**6.1** 128 PICKLES STREET SOUTH MELBOURNE

**PREPARED BY:** RICHARD LITTLE, SENIOR URBAN PLANNER

**1. PURPOSE**

- 1.1 To determine an application (316/2019) for the demolition of the two existing dwellings and boundary fences and the construction of buildings and works including a two-storey dwelling with swimming pool and car parking to the rear of the site.

Image: Basement level plan

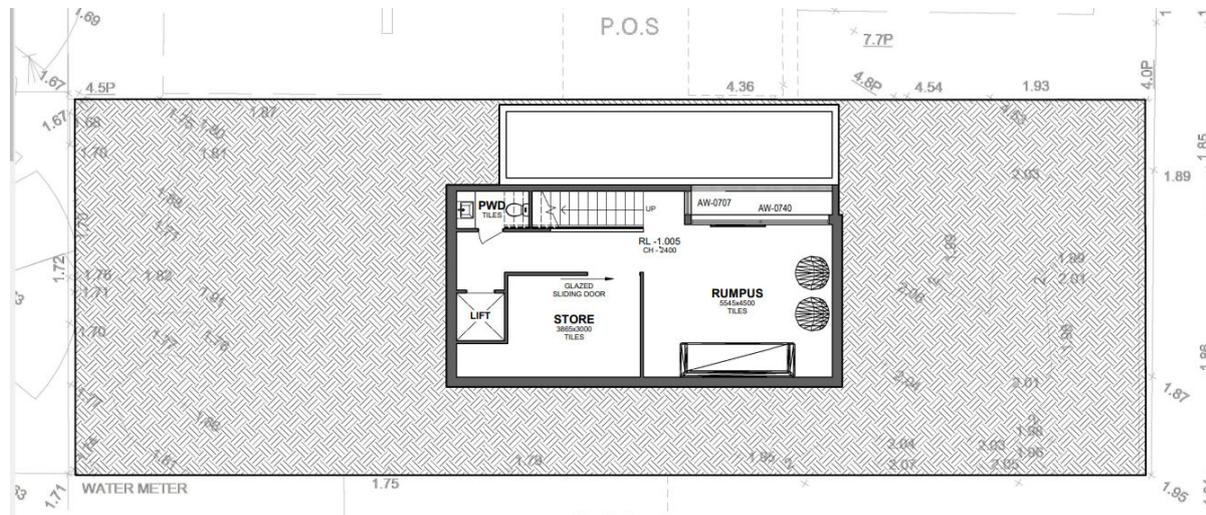
- The layout would consist of a lift, powder room, store, stairs and rumpus.
- The basement level would have an overall length of 11.6 m and a width of 6.2 m.

Image: Ground Floor plan

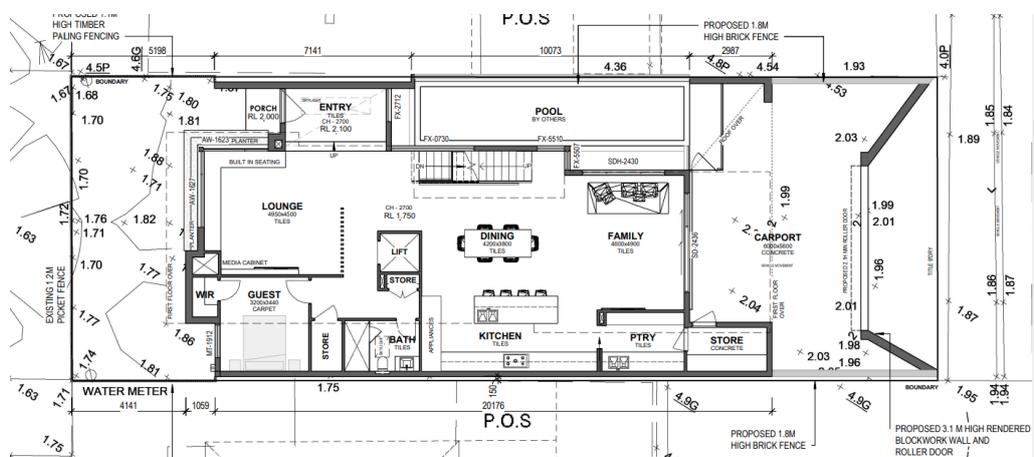
- b) The height of the rear wall, on either side of the roller door, to be a maximum of 1.8 m.
- c) The first floor setback of the en-suite (ENS) and walk in robe (WIR) to be increased to a minimum of 2.09 m from the southern boundary.

- The layout would consist of an entry, lounge, bathroom, lift, stairs, store, guest room open plan dining/ kitchen.
- To the rear of the dwelling would be a double car port and secluded private open space.
- The ground floor would have an overall length of 21.2 m and a width of 11.1 m.
- At ground floor the dwelling would be setback 4.14 m from the frontage.
- The proposed dwelling would be built along approximately two thirds of the southern boundary and partially built to the northern boundary.
- A 10m long pool is proposed along the northern boundary.
- To the rear of the dwelling would be 33.18 sqm of secluded private open space.

If the remainder of the application is considered to be acceptable, a condition would require the rear wall either side of the roller door to be reduced to 1.8 m in height.

Image: First floor plan

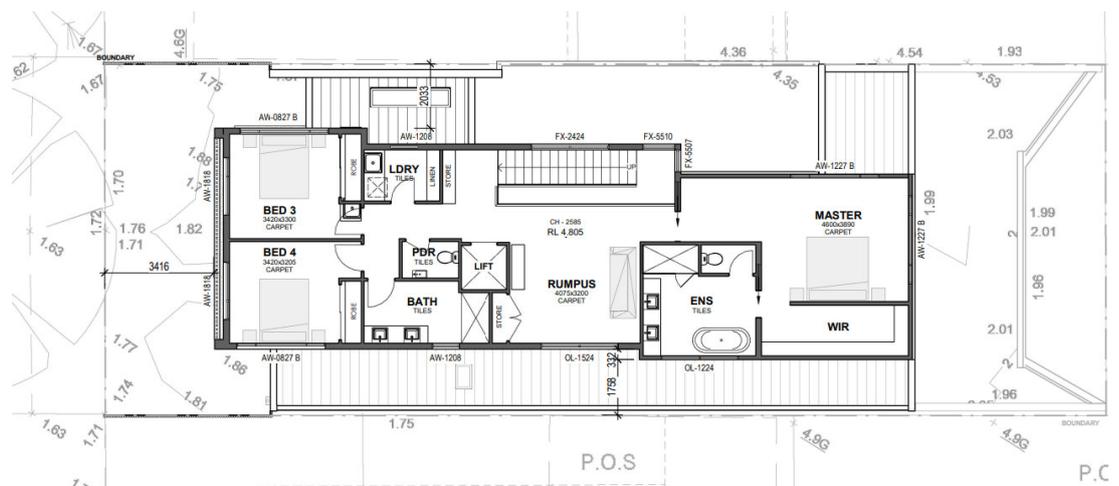
- The first floor would be setback 3.416 m from the frontage.
- The first floor would have an overall length of 21.9 m and a width of 6.9 m.
- The first floor would be setback 1.758 m and 2.09 m from the southern boundary, 5.9m to the eastern (rear boundary) and 2.02 m increasing to 3.5 m to the northern boundary.

In addition, it is recommended that the setback of the rear section of the first floor (en-suite and WIR) wall is proposed to be increased by 0.322 m (see discussion below). Whilst this would not eliminate all the proposed shadow, the levels of shadowing would be reduced and not be unreasonable. **(Refer Condition 1c)**

by increasing the first floor level setback to the southern boundary by 0.322 m, for the en-suite and WIR, to match the rest of the first floor setback of 2.09 m. This recommended modification (**Refer Condition 1c**) would help to reduce the overall amount of shadow produced.

Along the northern elevation are windows to bedroom 3, laundry, stairs and master bedroom. The window to bedroom 3 and the laundry would look over the front garden and car port of No. 43 Tribe Street. The windows to the stairs would be opposite the secluded private open space of No. 41 Tribe Street. Whilst stairs are not a habitable room, the rumpus room behind the stairs would be within 9m of the secluded private open space of No. 41 Tribe Street. If the remainder of the application is considered to be acceptable a condition would require the applicant to demonstrate that no direct views into the secluded private open space of No. 41 Tribe Street to a height of 1.7m above natural ground level, is possible from this window, otherwise the window to be treated to prevent overlooking. (**Refer Condition 1a**).

Again, the master bedroom window is within 9m of the secluded private open space of No. 41 Tribe Street. If the remainder of the application is considered to be acceptable a condition would require the applicant to demonstrate that no direct views into the secluded private open space of No. 41 Tribe Street to a height of 1.7m above natural ground level, is possible from this window, otherwise the window to be treated to prevent overlooking. (**Refer Condition 1a**).

On the southern elevation there are windows to bedroom 4, bathroom, rumpus and ensuite. Of these windows, bedroom 4 and the bathroom, would overlook the front garden and driveway of No. 126 Pickles Street. The remaining windows would be obscured and fixed shut to a height of 1.7 m above finished floor level.

- a) Sightlines to demonstrate that no downward views into the secluded private open space of No. 41 Tribe Street would be possible from the first-floor master bedroom and windows to the stairs. If the sightlines do not demonstrate that no overlooking is possible, then the windows to be treated to prevent the overlooking. Where louvre or batten screening is to be used, cross section elevation drawings of the screens must be submitted to and approved by the Responsible Authority. The drawings must:
